STAGE 2 (DETAILED) SSDA ACCESSIBILITY DESIGN COMPLIANCE STATEMENT

Project Name	INTERCONTINENTAL HOTEL
Project Address	115-119 Macquarie Street Sydney 2000
Prepared by:	Francis Lenny
Prepared for:	Mulpha Australia Limited c/- Built
Job Number:	38189
Date:	5 th August 2020
Revision:	3

ACCESSIBILITY STAGE 2 SSDA DESIGN REVIEW COMPLIANCE STATEMENT
INTERCONTINENTAL HOTEL TOWER – 115-119 MACQUARIE STREET NSW 2000

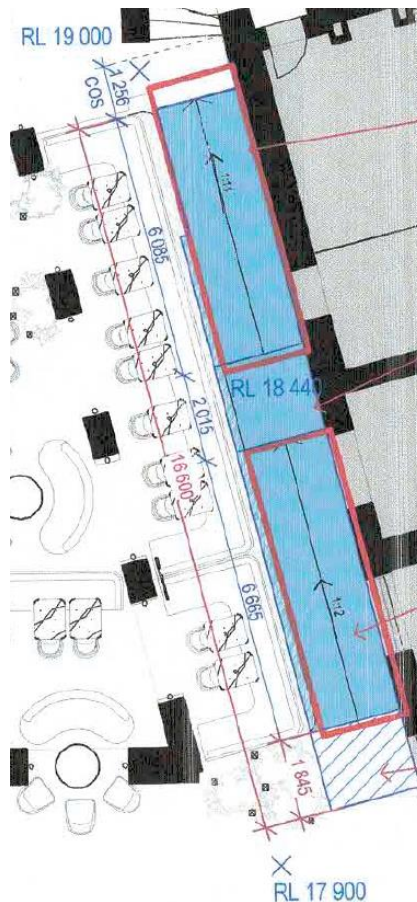
A review of the proposed project scope in terms of the Accessible Elements included as part of the future layouts of the building has identified the following items for consideration an inclusion within an Access Performance Solution report, which, it is understood will be developed at the CC application stage for the project:

- a) L5 External; Query grade of 'walkway' between top landing of new 1:10 step ramp and zone leading to property boundary – to be confirmed, as the design develops:

- b) L5 External; set-out of existing retained stairs – departure items may include absence of stair handrail horizontal terminations (300 mm minimum) at landing areas; domed buttons *may* be installed in lieu of TGSI's
- c) L5 Internal; some stair handrails *may* encroach into the traverse path of travel
- d) L5 Internal 'Cortile' ramp; retained non-compliant grades of 1:11 / 1:12 in lieu of 1:14; upper landing will have a length of 1256 mm in lieu of 1500 mm minimum to facilitate a 90° turn:
